Supplemental Information for September 23, 2021 HLC meeting *(Please note that italic text is copied from the application questions)*

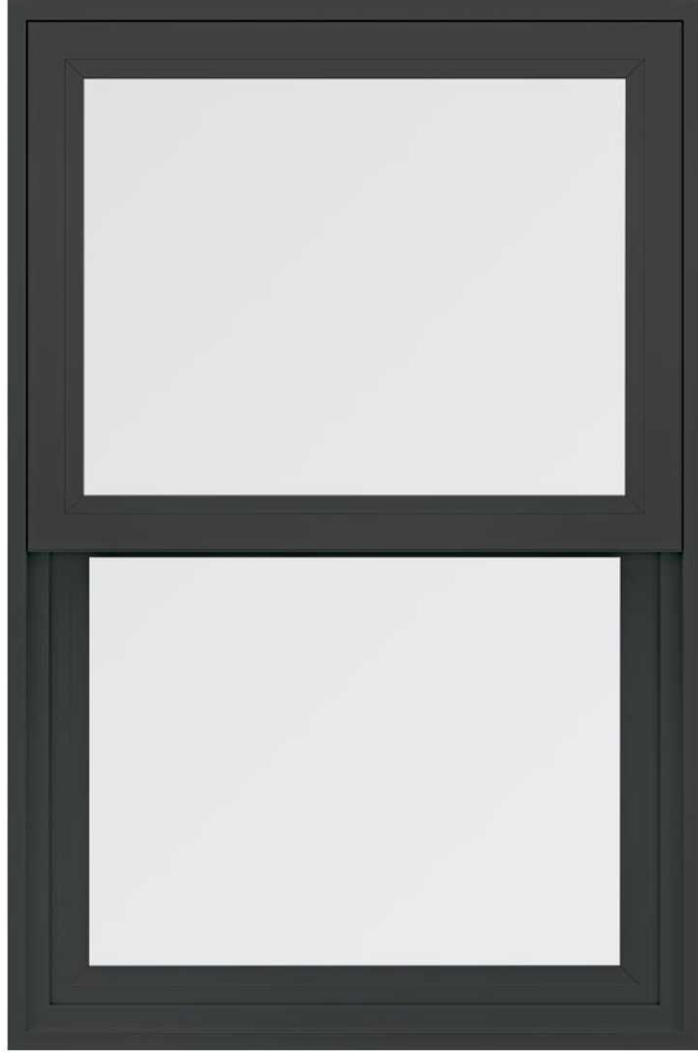
See examples of paint below, called "Rock Candy" (light grey for panels), "Gibraltar" (blue grey and will tie into stone veneer) and "Caviar" (bronze to match exterior windows) and the image was taken on white letter paper for reference and physical samples were hand delivered to the Planning Department on September 10, 2021:
